Mackie Road Reserve Pavilion redevelopment

Engagement summary report

JUNE 2024

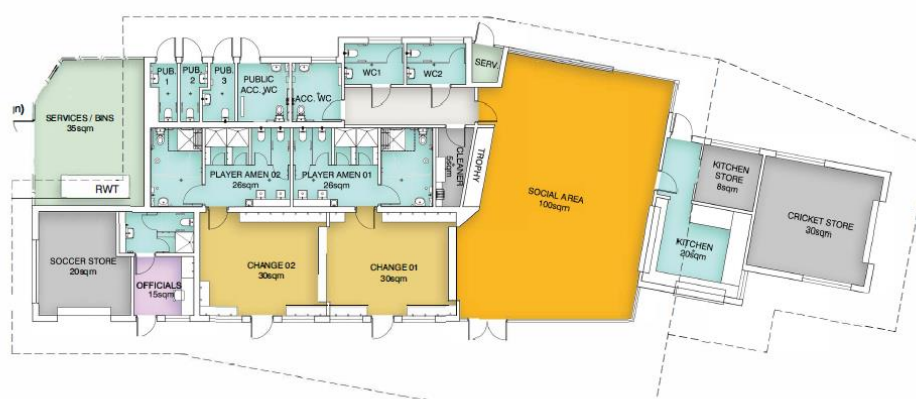
Question three asked survey respondents whether they could suggest any changes or improvements to the external design of the pavilion.

The comments have been analysed according to common themes. The top comments referenced themes around the need for more shelter and undercover protection across the front of the pavilion to support spectators, players, and the public from weather elements.

This was followed by responses related to the need for the pavilion to have more seating for spectators and players and more viewing spaces.

Specific comments about the external design of the pavilion related to:

- Negative views about the look of the building, i.e. too generic, toilet block looking, dislike of the roof design.
- A preference for it to be double storey with a rentable function room.
- Entry doors to be sliding and larger with more viewing windows that are openable for cross ventilation.
- A request for art murals on the empty wall spaces and glazed bricks.

Specific comments about the external space surrounding the pavilion related to:

- Removing landscape and bushes near the fence line obstructing oval view/ball retrieval.
- Enhancing wheelchair accessibility (by removing what appears to be a step up toward the pavilion).
- Catering to the need of dogs through fencing and a dog water tap.
- Adding exercise equipment in the park, more toilets and bike parking.

Theme area	# of times referenced	Summary	Illustrative quotes (verbatim)
Provide more shade, shelter, and undercover protection.	16 (41%)	Comments identified the need for more shade and shelter for all weather protection across the front areas of the pavilion façade.	<p><i>"The shade could extend out further in front of the canteen where spectators congregate"</i></p> <p><i>"Deeper eave overhang, or verandah on east side extending closer to the oval boundary, so scorers and spectators have shade / weather protection."</i></p> <p><i>"Make sure there is more pergola/veranda coverage at the front facing oval as we hot sun summers and wet cold winters. For practice and game times not only for games but spectators but also rest area with coverage for all other times for public."</i></p> <p><i>"Definitely needs more shade protection at front of pavilion."</i></p> <p><i>"There needs to be a larger undercover space to shelter from both rain and sun especially as large groups come to watch sport and would stand at the front of the club room not the side."</i></p>

Provide more seating and viewing spaces	10 (26%)	Comments identified the need for more and varied seating options and viewing spaces for spectators and players.	<p><i>"More seating or a viewing platform for sport so it's easier for spectators to see."</i></p> <p><i>"Seating could be included for spectators along the front of the pavilion."</i></p> <p><i>"Rooftop viewing space."</i></p> <p><i>"More outdoor seating and cover from weather for sporting teams etc."</i></p> <p><i>"It would be good to have a decent sized, covered viewing area for spectators...."</i></p> <p><i>"Would be great to have outside bar type seating similar to Centenary Park."</i></p> <p><i>"More benches."</i></p>
General feedback disliking the external look of the pavilion.	7 (18%)	Comments identified aspects of the design of the building and around it that were unappealing.	<p><i>"Looks underwhelming compared to some other local pavilions."</i></p> <p><i>"It looks like a generic sports building."</i></p> <p><i>"Not a fan of the roof design. Looks too beach."</i></p> <p><i>"...It looks uninviting and like a toilet block."</i></p>

Theme area	# of times referenced	Summary	Illustrative quotes (verbatim)
			<i>"The bushes at the front of this picture is terrible. Not needed at all and does not look nice."</i>
Upgrade doors and windows	3 (8%)	Comments focused on options to enhance the doors and windows for better viewing, ventilation, and appeal.	<i>"...Openable windows on front and rear sides of club room for cross ventilation. Larger portion of active facade."</i> <i>"Sliding glass doors instead of doors which open in or out creates a more appealing entry. Examples at HA Smith Reserve in Hawthorn, Jack Dyer Pavilion at Citizens Park Richmond."</i> <i>"Large glass windows to the front building will ease people to watch events from inside the building."</i>
More amenities around the pavilion /reserve	3 (8%)	Comments focused on requests to add amenities around the reserve rather than the pavilion itself such as adding an exercise park and bike parking.	<i>"It would be nice to have an exercise park! I live across from the park and it's frequently used for people walking around, the playground and walking dogs. I feel it would be well received."</i> <i>"install bike parking"</i>

Include dog friendly amenities	2 (5%)	Comments focused on provision for dogs around fencing and a dog hook outside toilets.	<i>"Please make it fully fenced for the dog lovers."</i>
Ideas to enhance the external design of the pavilion.	2 (5%)	Comments suggested incorporating more appealing decorative elements to the external design.	<i>"Some glazed bricks would be nice as highlights but it looks great overall."</i> <i>"It would be awesome to see: one or more art murals from members of the local community on the sides of the building that has a lot of plain unused space. That would give the space a unique feel and better connect it to the community."</i>
Wheelchair accessibility	2 (5%)	Comments focused on wheelchair accessibility.	<i>"Doesn't look wheelchair friendly with the step up externally."</i>
Make it double storey	2 (5%)	Comments included consideration for adding on a second story to the building with additional space.	<i>"Make it double storey. Function rooms above that can be rented by council. Land expensive. Under capitalizing by going single storey. Doesn't make sense."</i>

SK10

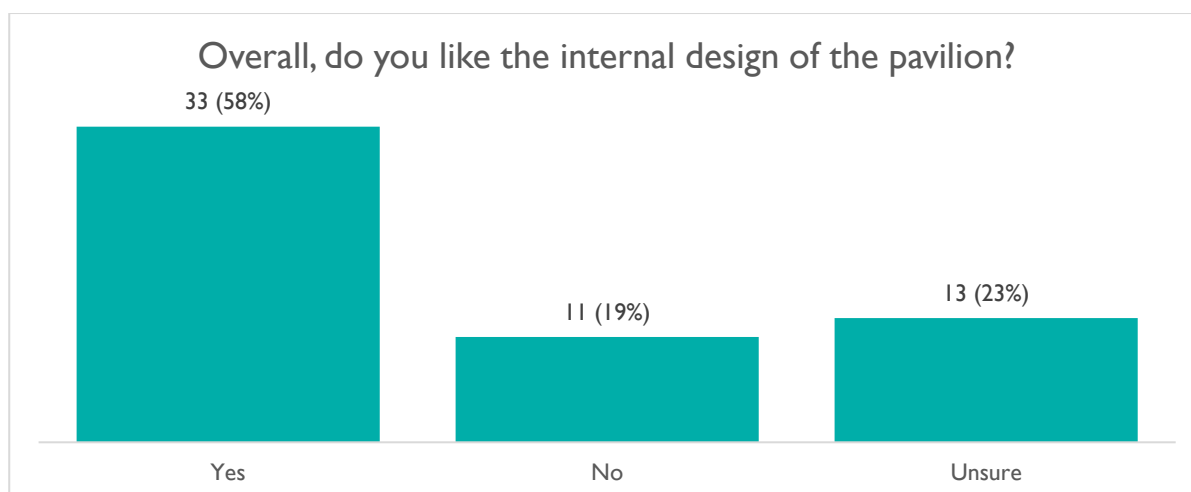
Question six asked survey respondents whether they could suggest any changes or improvements to the internal floorplan.

This was a mandatory and open-ended question. It was answered by 25 survey respondents (44 per cent) with 32 survey respondents (56 per cent) choosing to skip this question. The comments have been analysed according to common themes detailed in the table below.

Theme area	# of times referenced	Summary	Illustrative quotes (verbatim)
Modify toilets.	8	Comments recommend: <ul style="list-style-type: none"> more toilets in social area separate male and female toilets relocate public toilets to the front of pavilion for visibility and safety. add one more public toilet. less toilets as too many lacks disability bathroom with change facilities 	<p><i>"Three toilets servicing for 100m social space is not a great outcome for the facility. To only include this many WCs is short sighted and doesn't address the needs of large functions."</i></p> <p><i>"Having the public toilets at the back of the building poses a safety issue as there is no oversight of who is in/near the bathrooms, these need to be moved to be within full view of park users/sports participants."</i></p> <p><i>"Have male and female toilets. It's ridiculous."</i></p> <p><i>"Public toilets should be accessible from park and playground side where there are more people around making it safer."</i></p>

Theme area	# of times referenced	Summary	Illustrative quotes (verbatim)
Modify / increase size of social area.	6 (24 per cent)	Comments include: <ul style="list-style-type: none"> increase size of social area elongate social area to allow more viewing space. options for social area to be used for alternate purposes / hired out. add another exit to social area 	<p>“Social Area is too small for the size of the premises. There is more space for storage than social activities.”</p> <p>“Would definitely question cricket store to east opportunity for this to be at the rear and social rooms shaped differently so it is more elongated, to allow more viewing of the ground.”</p> <p>“a lot of bathrooms to maintain and only small social space that can have alternate purposes when not used by sports clubs.”</p> <p>“Social area could probably use an additional exit”</p>
Add another storey or roof viewing space.	3 (12 per cent)	Comments included adding another storey or roof viewing space to assist with viewing and scoring.	<p>“Larger social area or spectator viewing area potentially upstairs?”</p> <p>“Maybe a viewing area on the roof of the pavilion.”</p> <p>“It would be better the building has two levels. (Upstairs) As per scoring and may be commentary purposes need a better view.”</p>

Provide a third change room for women.	2 (8 per cent)	Comments identified a lack of change rooms that cater for the needs of girls/women.	<p>“I would have thought there needs to be more than 2 change rooms in the plan. What if there is a girl's game directly after a men's game. Where will the girls feel safe to change?”</p> <p>“There are only two change rooms / shower areas - these will always be allocated to the home&away teams playing on the main oval - which is never the women's teams. Provide a third change / shower area, for women's teams.”</p>
Positive feedback on the internal floorplan design	2 (8 per cent)	Positive comments for design.	<p>“Great design”</p> <p>“Looks good!”</p>
Include a publicly accessible AED defibrillator.	1 (4 per cent)	Feedback on inclusion and location of an AED defibrillator.	<p>“There is currently an AED (defibrillator) at the pavilion. Is there provision for this in the new Plan?”</p>

Theme area	# of times referenced	Summary	Illustrative quotes (verbatim)
			<i>Will the AED be more publically accessible than at present?"</i>
Allow sufficient kitchen area.	1 (4 per cent)	Feedback on needs for kitchen area.	<i>"Please allow enough kitchen area to have a central bench for food preparation. Need to also fit a large stove as well and a wall of fridges for drinks display."</i>

The survey responses reinforced earlier feedback previously noted such as:

- Consideration to add a second storey.
- Reduce the number of toilets at the pavilion.
- Increase toilets in social area.
- Provide internal access to showers /change areas.
- Include openable skylights in change rooms for ventilation.
- Provide rain shelters.
- Ensure wheelchair accessibility.
